Access Compliance Report

Public Rights-of-Way

(Curb Ramps)

Intersection ID: N/A	Main Street: REA_RD	Cross Street: N/A	Location: SE
ADA ID: 0C9642F6C623	Ramp Type: Perp	Initial Pass/Fail: Fail	Overall Compliance: No
Severity Score: 21.25			
Codes/Mitigation Info/Possible Solution		Field Measurements/Component Compliance

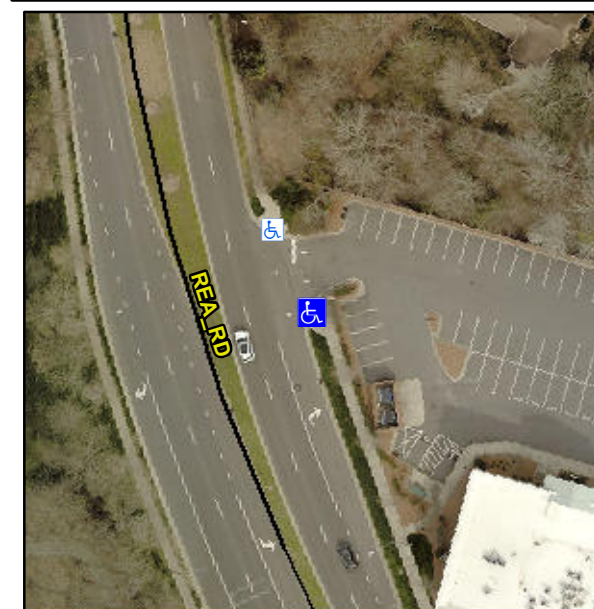
R304.5.1, R304.5.3

Compliance	Description	Data	Compliance	Description	Data
N/A	Ramp Length (in)	130.0	Yes	Ramp Slope (%)	6.4
No	Ramp Width (in)	47.0	No	Ramp XSlope (%)	5.2
N/A	Flare Type LT	N/A	N/A	Flare Type RT	N/A
N/A	Flare Slope LT (%)	N/A	N/A	Flare Slope RT (%)	N/A
N/A	Flare Traversable LT?	N/A	N/A	Flare Traversable RT?	N/A
N/A	Landing Length (in)	N/A	N/A	DWS Provided?	N/A
N/A	Landing Width (in)	N/A	N/A	DWS Contrast?	N/A
N/A	Landing Slope (%)	N/A	N/A	DWS Length (in)	N/A
N/A	Landing X Slope (%)	N/A	N/A	DWS Full Width?	N/A
N/A	Landing Curb? (Y/N)	N/A	N/A	DWS Offset (in)	N/A
N/A	Shared Landing?	N/A			
N/A	Gutter Ponding?	N/A	N/A	Gutter Slope (%)	N/A
N/A	Gutter Lip Ht (in)	N/A	N/A	Gutter X Slope (%)	N/A
N/A	Painted X Walk1?	No	N/A	Painted X Walk2?	N/A
	X Walk 1 Direction	To N		X Walk 2 Direction	N/A
N/A	X Walk 1 Width (in)	N/A	N/A	X Walk 2 Width (in)	N/A
	X Walk 1 Slope (%)	2.2		X Walk 2 Slope (%)	N/A
	X Walk 1 X Slope (%)	2.8		X Walk 2 X Slope (%)	N/A

Remove & Replace Entire Ramp.
